Attachment K – Detailed Response to Submissions Table

Attachment K – The Children’s Hospital at Westmead - Multi-storey Carpark (SSD-10434896) – Detailed Response to Submissions Table

Figure 4 PLR construction vehicle route
Source: NSW Department of Planning, Industry and Environment

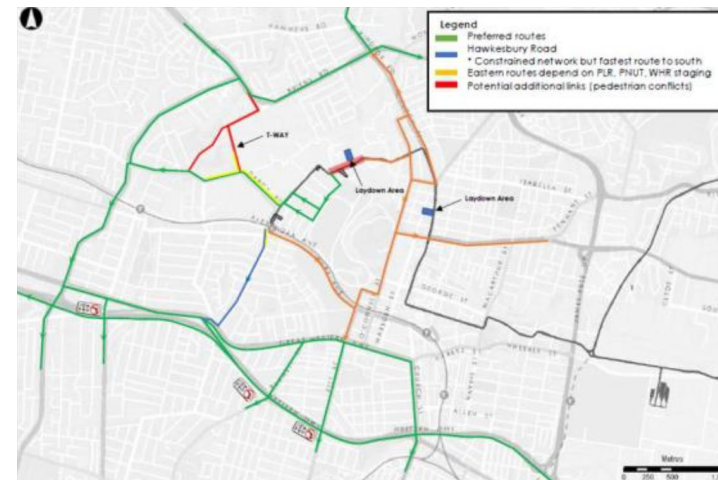
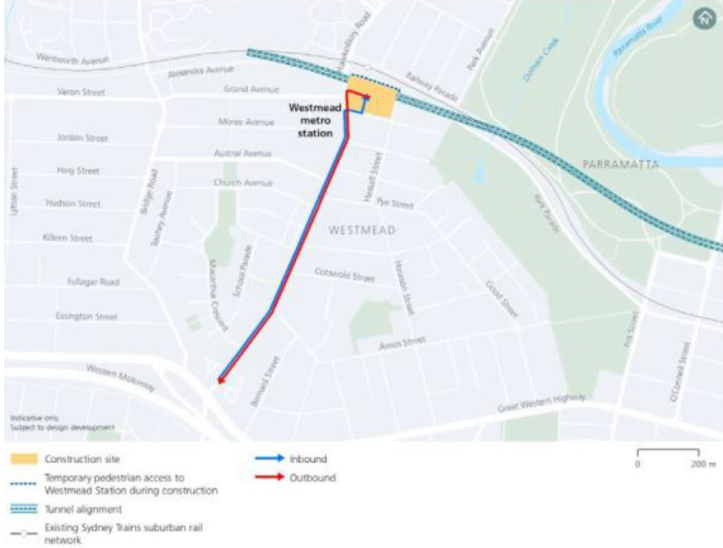
6	<p><i>Transport</i></p> <p><i>The cumulative construction impacts are to be further investigated and assessed, taking into consideration light rail works and concurrent building construction works.</i></p>	<p>It is expected construction of the MSCP may coincide with construction of the Parramatta Light Rail (PLR) and Sydney Metro West.</p> <p>While construction vehicles will have origins and destinations from a wide variety of locations, construction vehicles are generally limited to the arterial road network, and dedicated construction vehicle routes are developed with the aim to provide the shortest distances to/from the arterial road network.</p> <p>The primary construction vehicle routes for the MSCP are likely to include to/from north and east via Redbank Road and Briens Road and to/from south and west via Institute Road, Darcy Road and Cumberland Highway. Redbank Road would be the preferred route, as it provides a more direct access between the site and the arterial road network to/from the site from the north-east.</p> <p>It is understood that the primary construction vehicle route for Sydney Metro West and Westmead Metro Station would be Hawkesbury Road and the M4 highway to</p>

These routes are shown in Figure 6.3 of the updated Traffic Assessment Report, at **Attachment G**, and extracts also provided below in **Figure 4** and **5**.

<p>Figure 5 Sydney Metro West construction vehicle route Source: NSW Department of Planning, Industry and Environment</p> <p>Given the low anticipated peak construction activity and the differing primary construction vehicle routes for the MSCP, it is not anticipated that the cumulative construction impacts would be measurably greater than isolated construction impacts.</p> <p>Nonetheless, it is anticipated as a requirement of a condition of consent, the proponent shall prepare a Construction Pedestrian and Traffic Management Plan (CPTMP) prior to the issue of any Crown building works certificate in consultation with TfNSW.</p>
7	<p>Transport</p> <p><i>Outline the staging that will be implemented in the realignment of Redbank Road to minimise the impact on vehicles and pedestrians.</i></p>	<p>The realignment of Redbank Road is to be implemented in stages to minimise the impact on vehicles and pedestrians. The appointed contractor will be responsible for the detailed construction staging. It is anticipated the contractor will always ensure a single traffic lane is maintained along Redbank Road during all stages of the realignment. The contractor would be responsible for maintaining two-way traffic activity with stop-go traffic control whilst ever the single lane is in place. However, the final staging will be confirmed by the appointed contractor for the</p>

Figure 7 Bathroom facilities including accessible toilets at Level 1 of the existing Children's Hospital at Westmead and near the Galleria
Source: SCHN (2021)

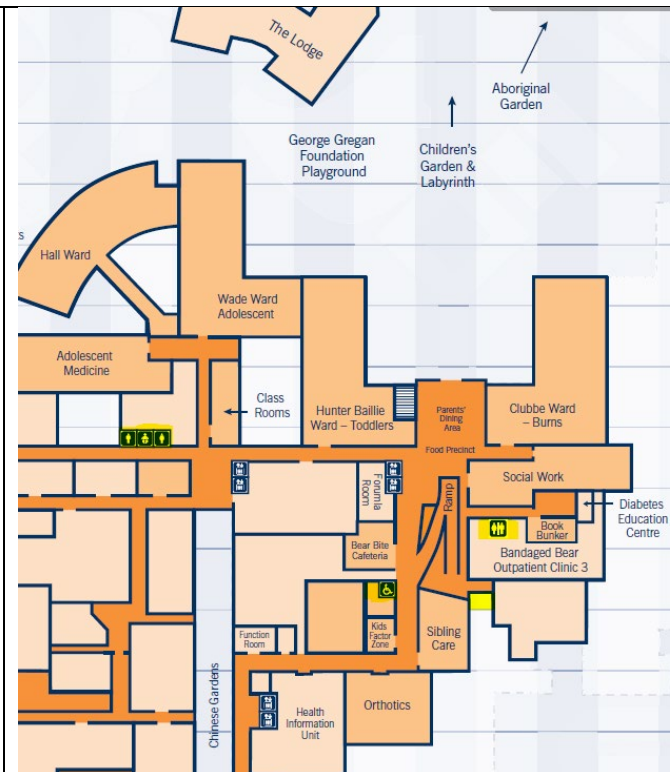
44	<i>Loss of playground due to MSCP development</i>	<p>The existing playground is proposed to be removed and relocated.</p> <p>The proposed new playground will match the size of the existing playground set for demolition, with some existing equipment to be retained and relocated.</p> <p>It is noted that the proposed playground is to be undertaken as exempt development i.e. not subject to approval under this SSDA.</p> <p>A additional new playground is proposed nearby on site in the KIDSPARK under the separate, but concurrent, SSDA application for the PSB.</p>
45	<i>Need Bathroom facilities for disabled children in the carpark</i>	Public amenities including bathroom facilities are not a code requirement and have not been requested by the BCA or DDA consultant. As the car park is a 24-hour operational facility, the provision of public amenities within the building could pose a security risk during quieter hours. Accessible parking spaces are positioned close to the lift lobby and in turn, the car park is sited within close proximity to the Galleria and its public facilities which includes accessible bathrooms and change rooms (refer to Figure 7). Wayfinding signage will also be used to direct patrons to the Galleria.
